Video Products Technical Bulletin 30-2002-175R2

DATE: June 1, 2009 SUBJECT: POWER AND HOUT TRANSISTOR FAILURE

MODEL: BVM-D9H1A

Figure 1

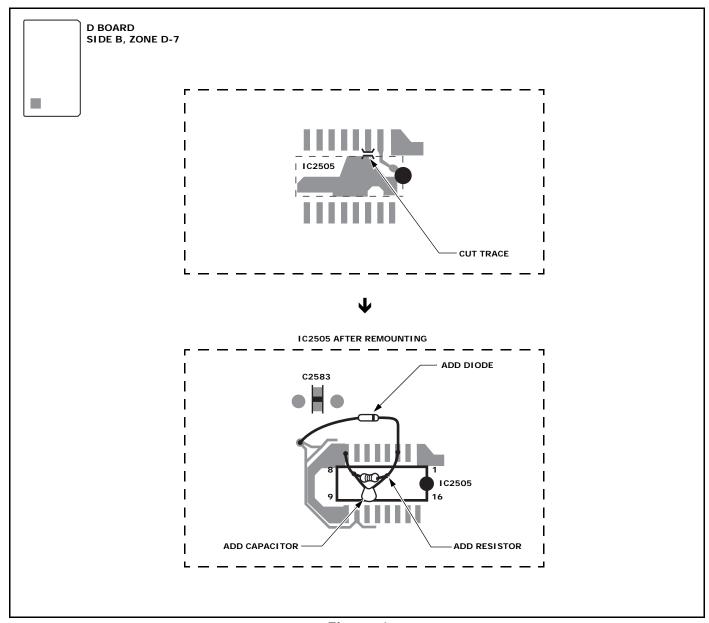
3. Remove C2632 (220 µF), which is soldered in parallel with R2553 (zone B-6).

(See Figure 1.)

- 4. Modify the H SYNC circuit on the D board by adding individual components as follows:
 - a. Remove IC2505 (zone D-7).
 - b. Cut the trace leading from IC2505 pin 3.
 - c. Replace IC2505 with a new IC (TC74HC4538AF).
 - d. Solder the cathode of a new diode (1SS119) to IC2505 pin 3.
 - e. Solder the anode of the diode to the thru-hole on the lower left side of C2583.
 - f. Solder a 0.1 μF capacitor between pins 3 and 8 of IC2505.
 - g. Solder a 1 $M\Omega$ resistor to both leads of the capacitor.
